Aboni Knitwears Ltd

Tatulzhora-Rishipara road, Savar, Dhaka
(+23.7930,+90.2603)

25 September 2013

**Check on Column stress levels immediately
required**

Item 1 High Stress to Building internal columns

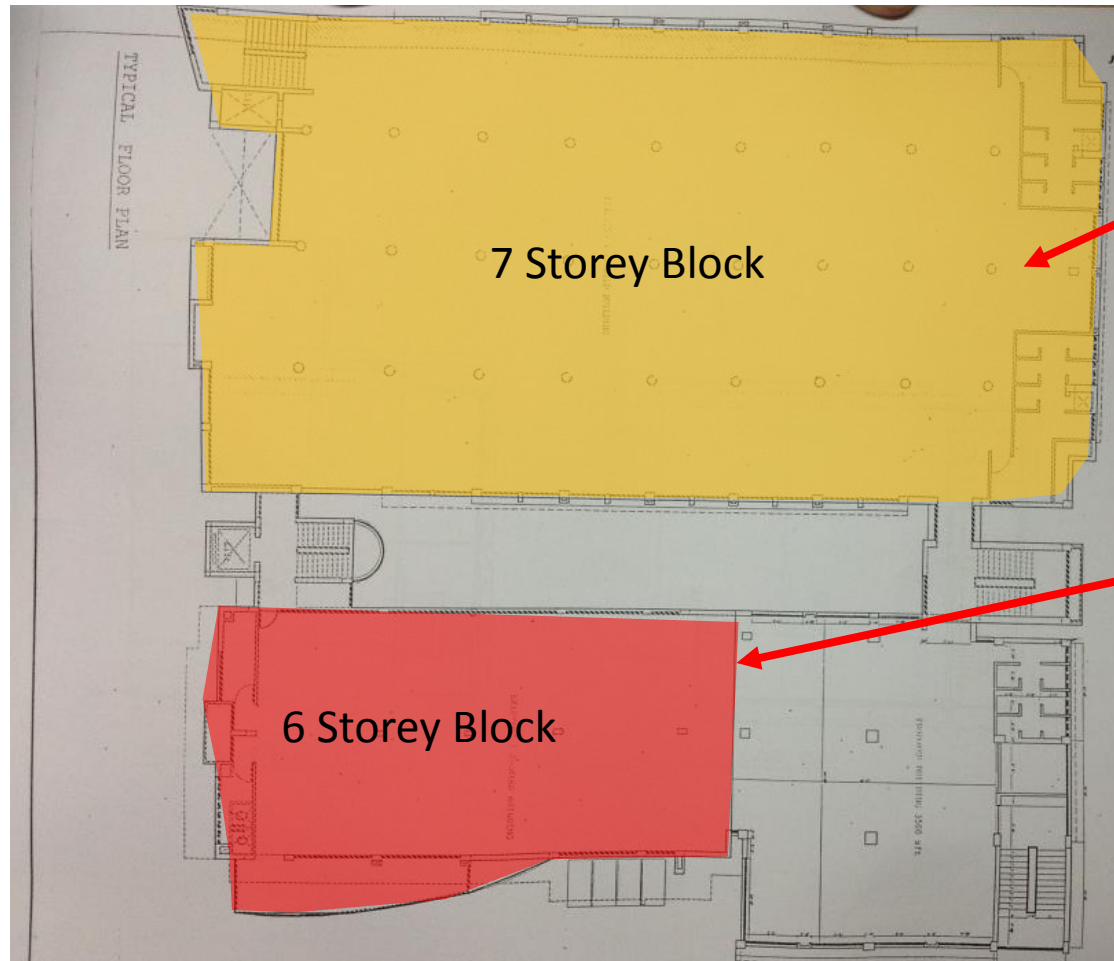
Verify concrete strengths in internal columns and reduce loads

No storage in this area on any level, limit all live load to a maximum of 2.0kN/m^2 , on any floor, immediately

Remove all personnel from this building until results of columns strengths and Building Engineering assessment is complete

Item 1 High Stress to Building internal columns

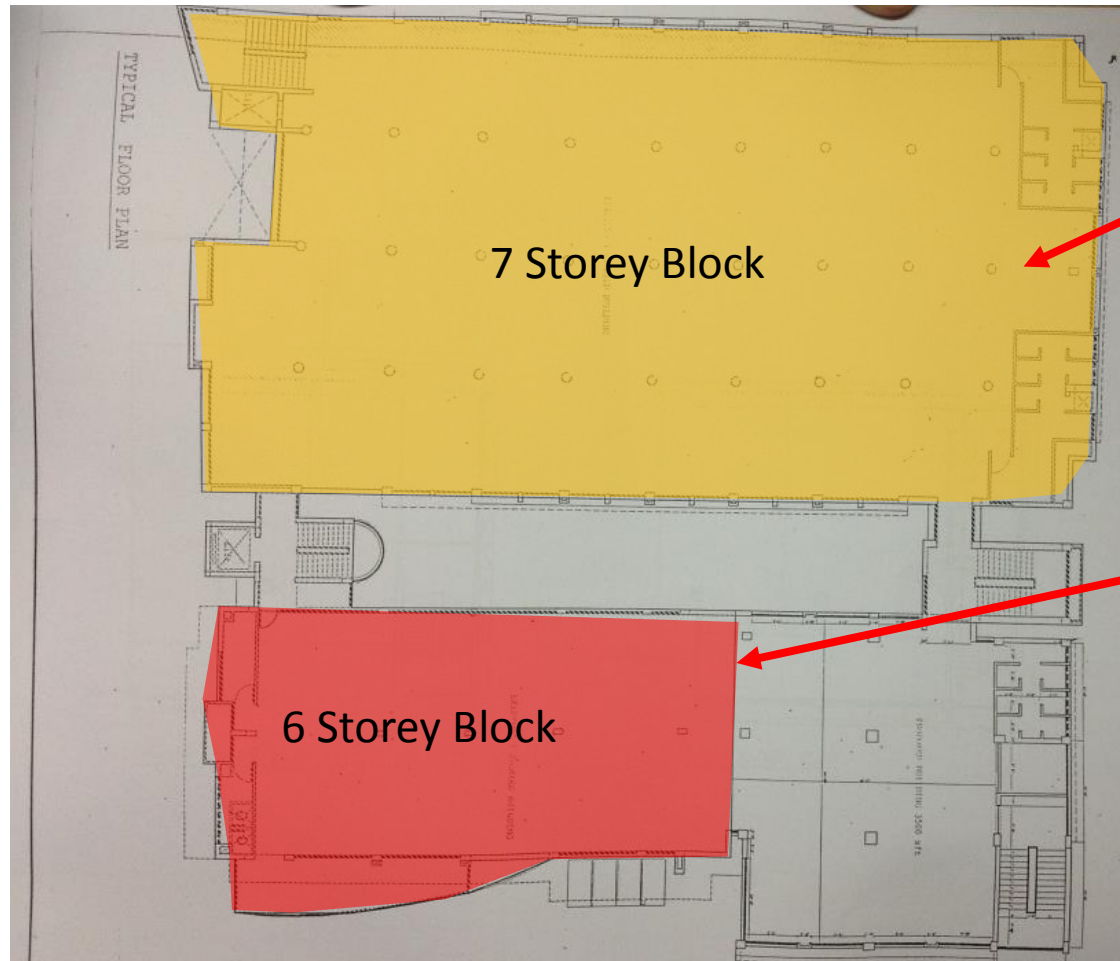
Verify concrete strengths in internal columns and reduce loads

No storage in this area on any level, limit all live load to a maximum of 2.0kN/m^2 , on any floor, immediately

Remove all personnel from this building until results of columns strengths and Building Engineering assessment is complete
